Re: *Application for Combined Preliminary/Final Plat Approval for Filing 11-AMENDED*

**RE: Filing No. 11, Castle Valley Ranch Planning Area #17
Preliminary and Final Plan Review - SGM Response**

**RE: Filing No. 11, Castle Valley Ranch Planning Area #17
Preliminary and Final Plan Review**

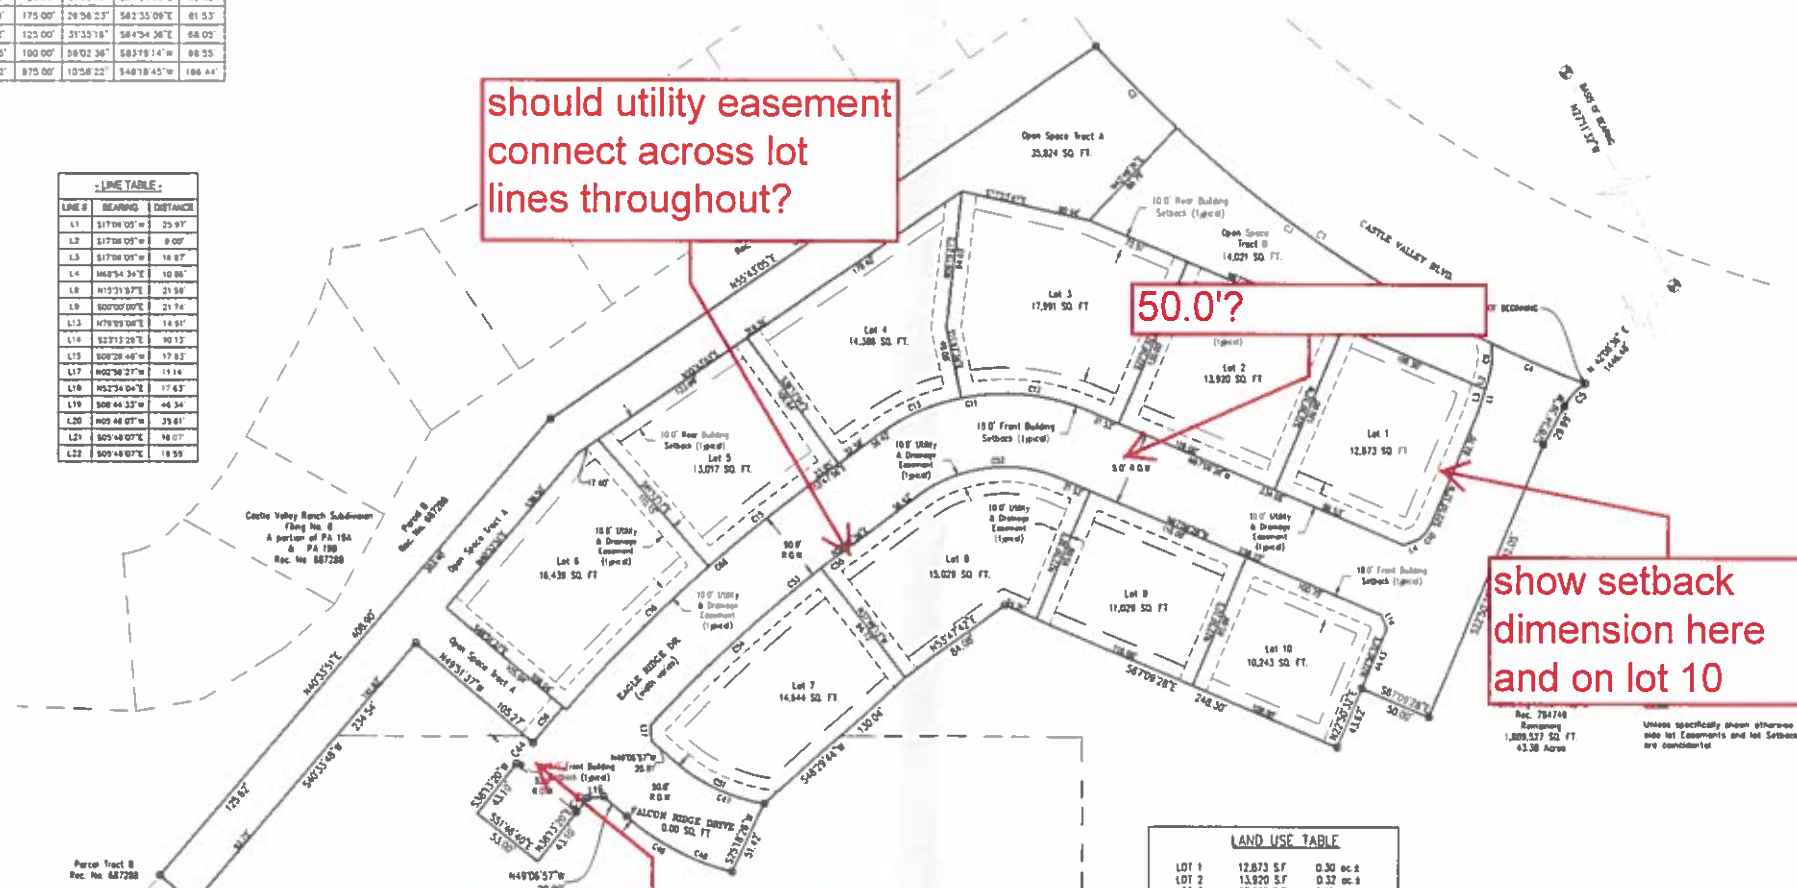
should utility easement connect across lot lines throughout?

50.0'?

show setback dimension here and on lot 10
